PROPOSED FRONT
ELEVATION

DRAWING No 6 REV 03

90 TORRANO AVE

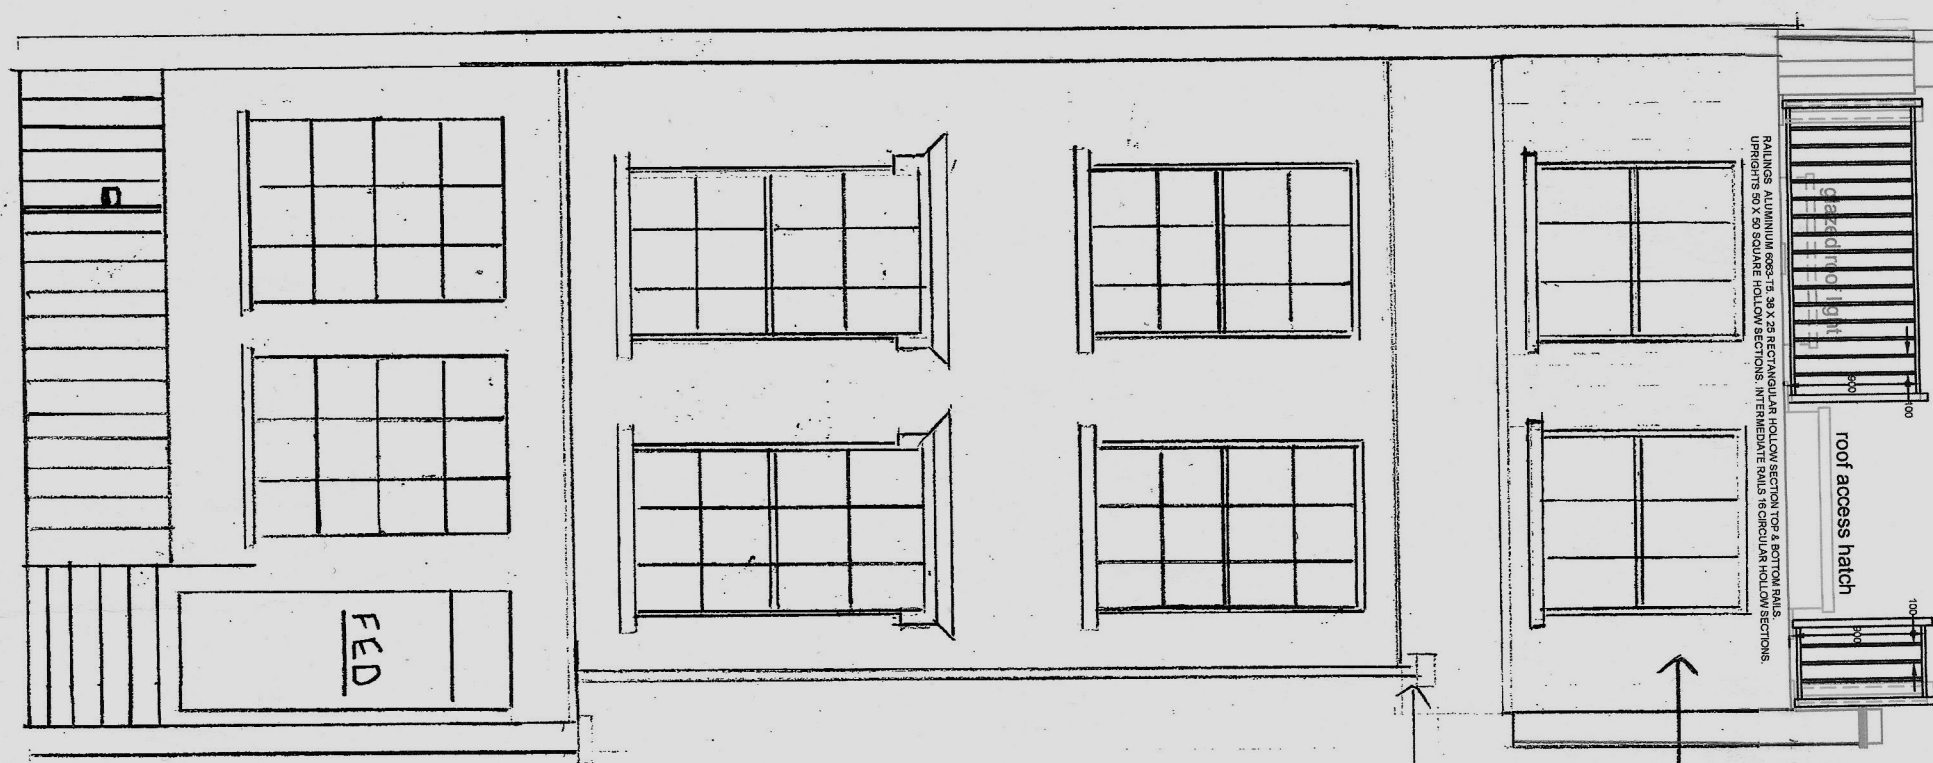
The vertical slatted timber rails guarding & handrail removed from
frontage flat topped mansard roof & reduced in extent to two
sides. New lightweight aluminium black painted railing system
installed to new setting out position ensuring not visible from
street level pavement to provide safe roof maintenance guarding.

RAILINGS: ALUMINIUM 6063-T5 38 X 25 RECTANGULAR HOLLOW SECTION TOP & BOTTOM RAILS
UPRIGHTS 50 X 50 SQUARE HOLLOW SECTIONS, INTERMEDIATE RAILS 18 CIRCULAR HOLLOW SECTIONS.
1000
800
600
400
200
0
